## SUBMITTAL SUMMARY REPORT PrelimPlat-000680-2026

**PLAN NAME:** Heatherwood  
**APPLICATION DATE:** 04/24/2026  
**DESCRIPTION:** Heatherwood

Heatherwood Preliminary Plat  
#PrelimPlat-000680-2026

**COVER SHEET**

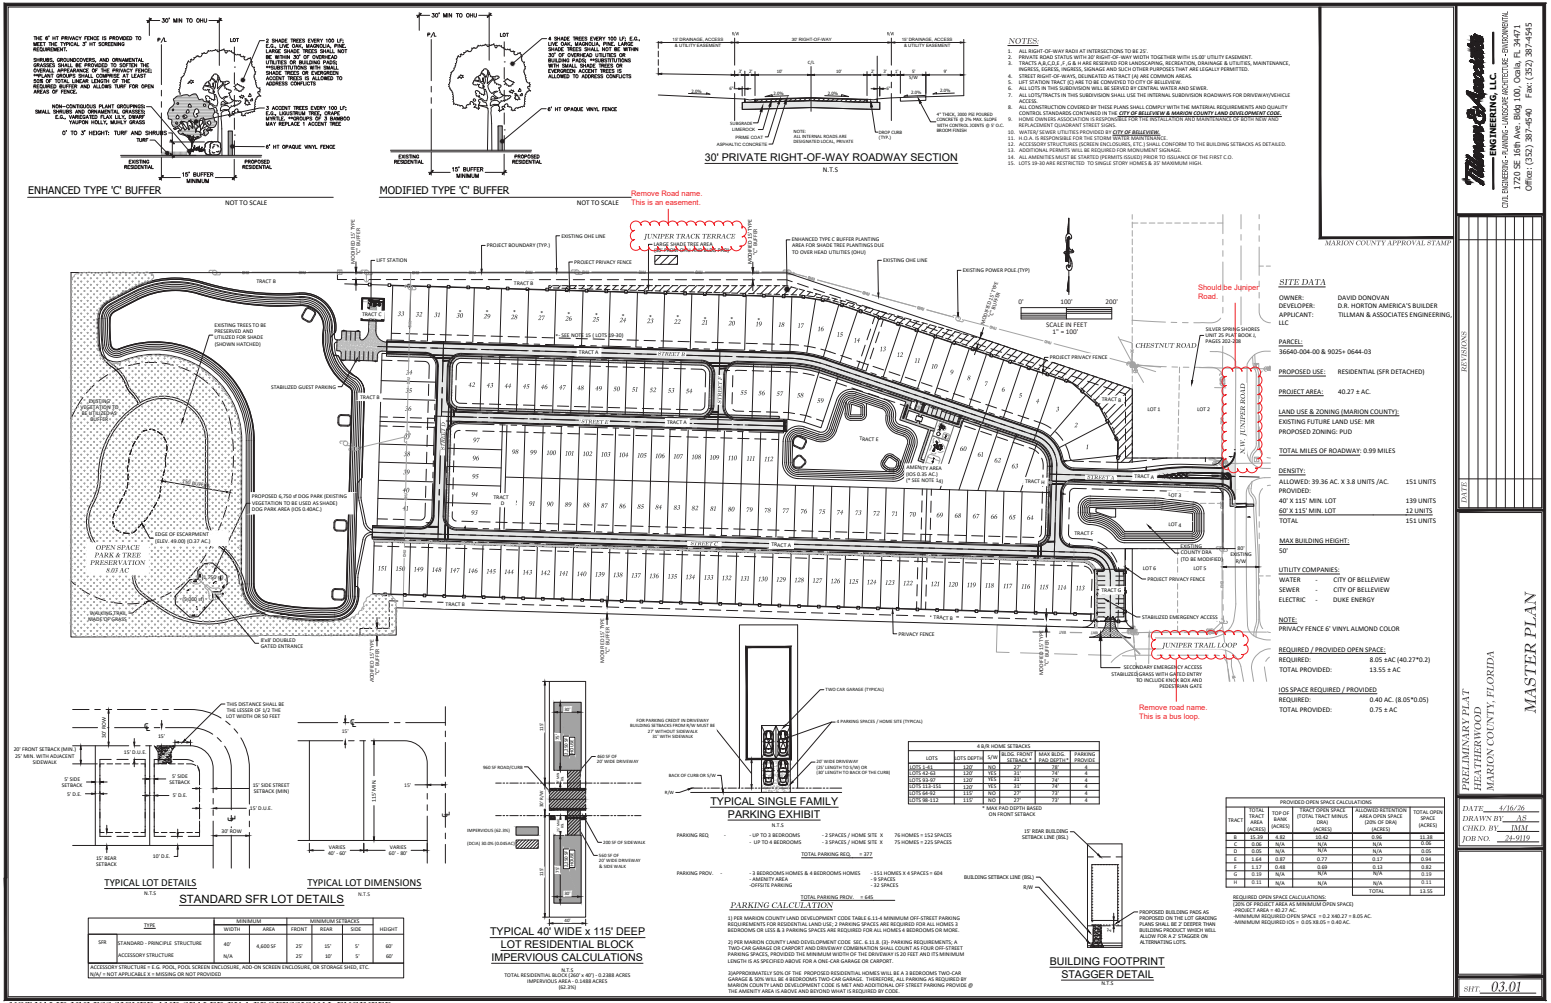
REVIEWER	MARKUP	DATE/TIME	FILE NAME	PG #
Kristie W	Remove road name. This is an easement.	04/29/2026 5:01	PM_Combined Plans.pdf	2
Kristie W	9-1-1 REQUIRES RESUBMIT	04/29/2026 5:03	PM_Combined Plans.pdf	1

SHEET: 04.01

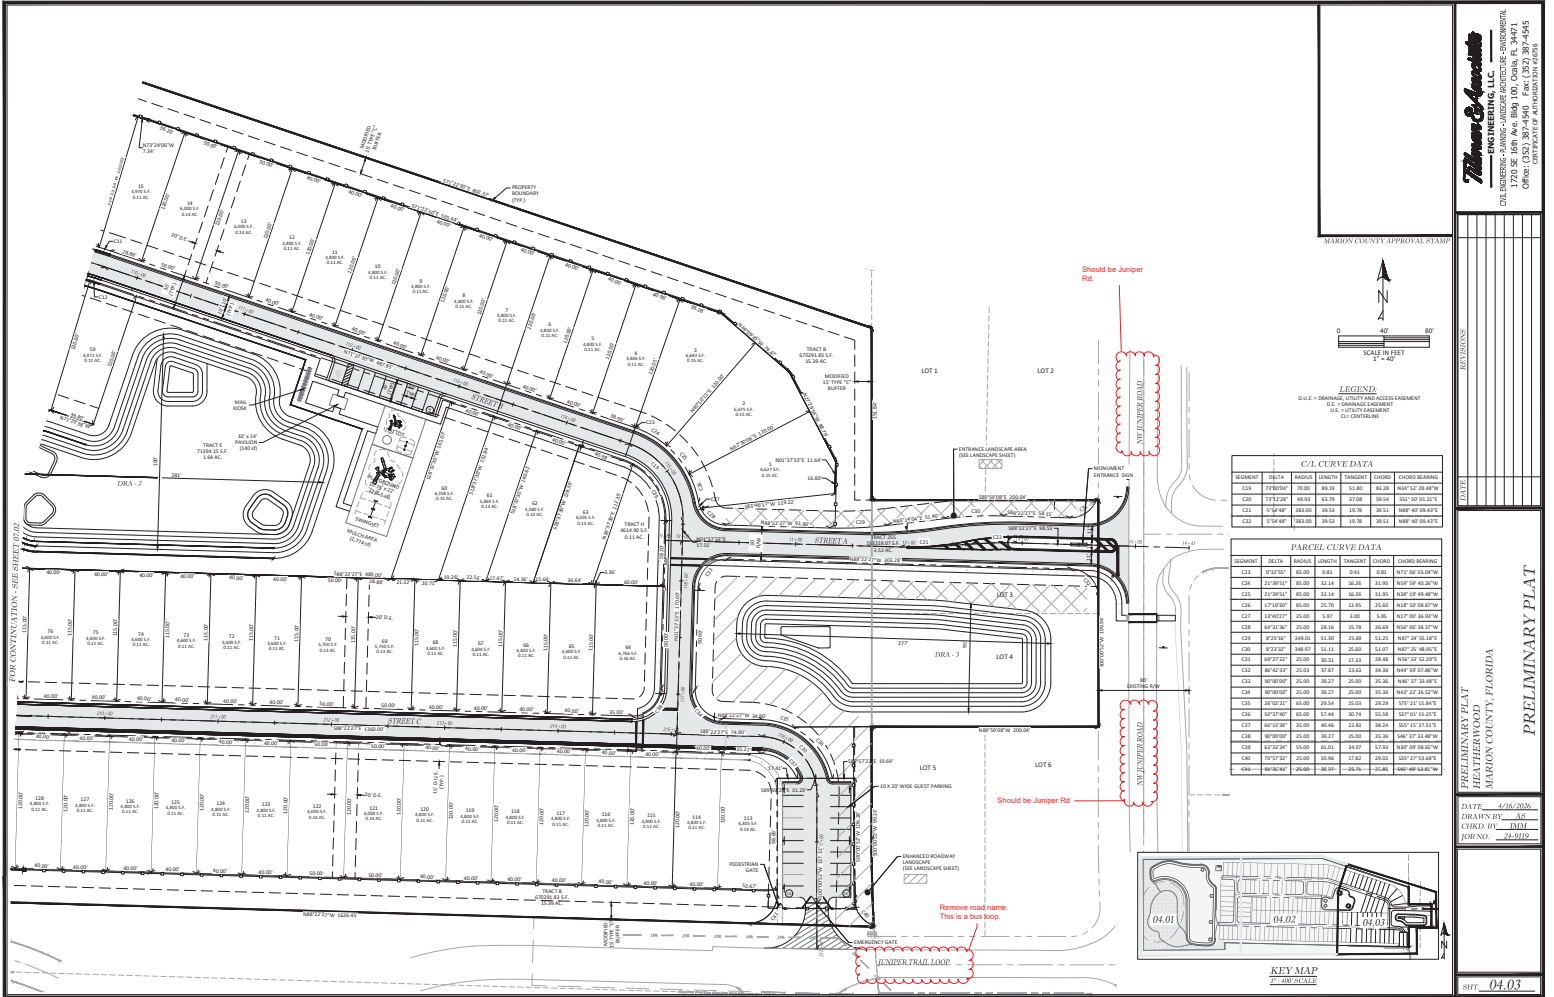
REVIEWER	MARKUP	DATE/TIME	FILE NAME	PG #
Kristie W	Remove Road name. This is an easement.	04/29/2026 5:04	PM_Combined Plans.pdf	3
Kristie W	Should be Juniper Road.	04/29/2026 5:04	PM_Combined Plans.pdf	3
Kristie W	Remove road name. This is a bus loop.	04/29/2026 5:07	PM_Combined Plans.pdf	3
Kristie W	We cannot name roads at this time due to the CAD file not containing the layers we need to be able to name the roads.	04/29/2026 5:08	PM_Combined Plans.pdf	2
Kristie W	Should be Juniper Rd.	04/29/2026 5:10	PM_Combined Plans.pdf	6
Kristie W	Should be Juniper Rd	04/29/2026 5:10	PM_Combined Plans.pdf	6
Kristie W	Remove road name. This is a bus loop.	04/29/2026 5:11	PM_Combined Plans.pdf	6
Kristie W	Please remove road name. This is an easement.	04/29/2026 5:14	PM02.01 AERIAL PHOTOGRAPH.pdf	1
Theresa S.	Sec. 2.12.8. - Current boundary and topographic survey.Current boundary and topographic survey (one foot contour intervals extending 100 feet beyond the project boundary) based upon accepted vertical datum. Surveys will be less than 12 months old and accurately reflect current site conditions, meeting standards set forth in Ch. 5J-17 FAC. Alternate topographic data may be accepted if pre-approved by the Marion County Land Surveyor.(Ord. No. 13-20, § 2, 7-11-2013)	05/06/2026 9:39	AM_Boundary Topo Survey.pdf	1
